U. S. ATOMIC ENERGY COMMISSION  
DIVISION OF COMPLIANCE  
REGION V

Report of Inspection

CO Report No. 50-275/70-2

Licensee: Pacific Gas & Electric Company  
Construction Permit No. CPPR-39  
Category A

FIGURE 4 - Diablo Canyon Construction Site. (Note Close Proximity to Ocean)

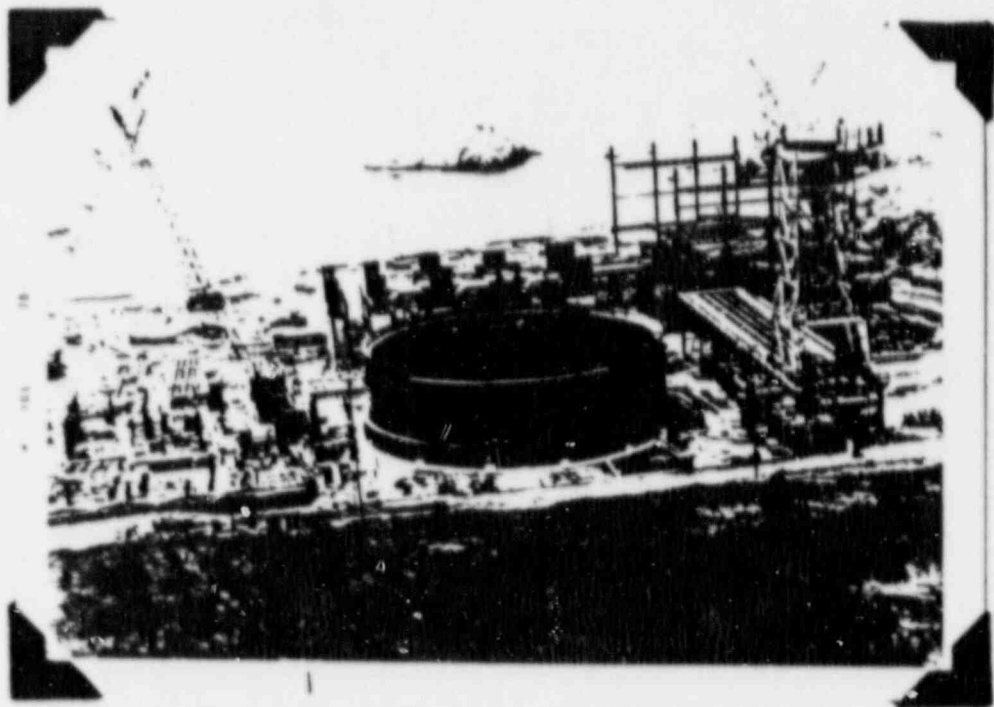
Considering the close proximity of the Diablo Canyon site and the Pismo Beach storage yard to the ocean; the inspector asked to what extent potential contamination of stainless steel materials by a salt-air environment had been evaluated. Specific reference was made to such item as core internals, etc.

Mr. Hersey stated that stainless steel materials at the Diablo Canyon site are to be stored either inside a warehouse or covered with plastic or other suitable materials.

FIGURE 5 - Wide Flange Beams to be Installed in the Base Section of the vertical walls of the Containment Building.

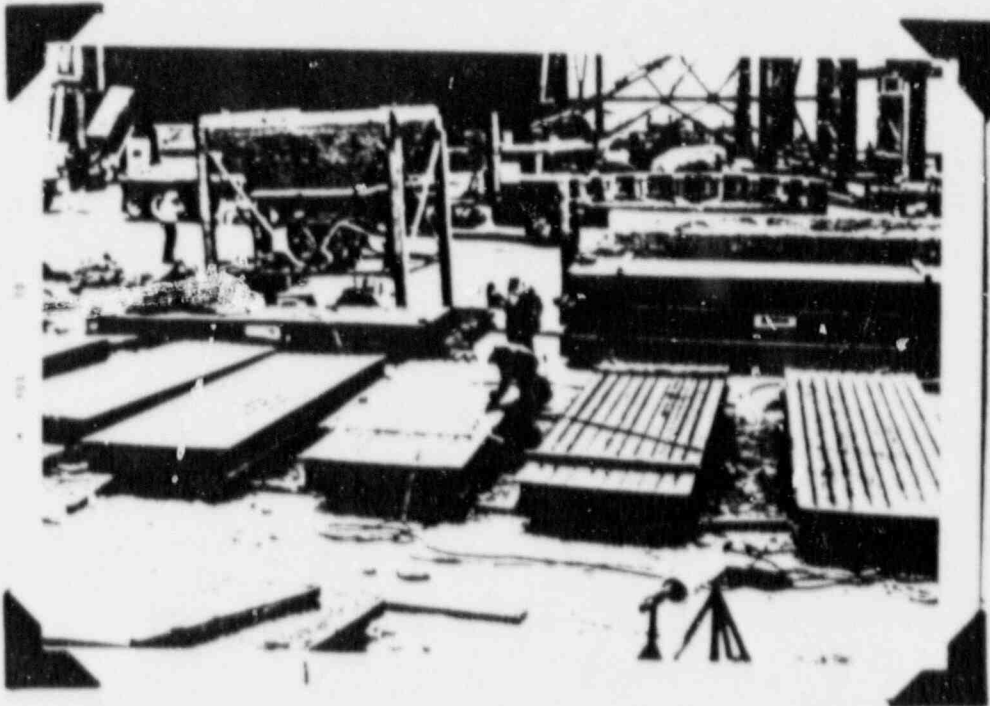
The first section of the vertical side walls of the containment are to be constructed by installing 12 inch wide flange beams (20 feet long) circumferentially around the containment liner. The beams are positioned vertically and rest on the base mat. (Figure 5 shows the beams) The edge of the beams are to be located a distance of 12 inches from the liner plate. The concrete to be installed between the liner wall and the beams will be reinforced circumferentially with steel hoop and diagonally by helicoidal bars (No. 18 reinforcing steel).

The licensee has approved a special concrete mix to be placed in the space between the flanges and the containment liner. The mix was designed for a strength of 3000 psi; with the slump specified as 5 inches. The maximum aggregate size was specified to be 3/4 inch.

Mr. R. R. Friedrichs, Resident Civil Engineer, explained that the conditions of the pour had been reviewed with Design Engineering and contractor (G. F. Atkinson Co.) personnel. According to Mr. Friedrichs, all interested parties had concluded that the use of the special design mix, along with careful placement and vibration of the concrete, should result in quality concrete. He stated that, since the pour space is limited to approximately 12 inches, the segregation that would occur should not be significant and that careful vibration should assure proper consistency of the concrete. Friedrichs indicated the increase in slump and vibration should eliminate any significant voids. However, as a crude check to assure against gross voids, the quantity of concrete placed will be compared to the calculated volume of the space to be filled.

Mr. Fredricks indicated that the plan to install a special design mix of concrete in the area between the wide beam flanges and the containment liner at the base of the containment sides will receive further evaluation. A determination will be made as to whether a mockup section of the area should be poured to demonstrate that the resulting concrete meets the design requirements.

Subsequent to the discussions and during the management interview, Friedrichs stated that consideration would be given as to whether or not to build a mockup section of the area and make a pour so that the resulting concrete could be analyzed.
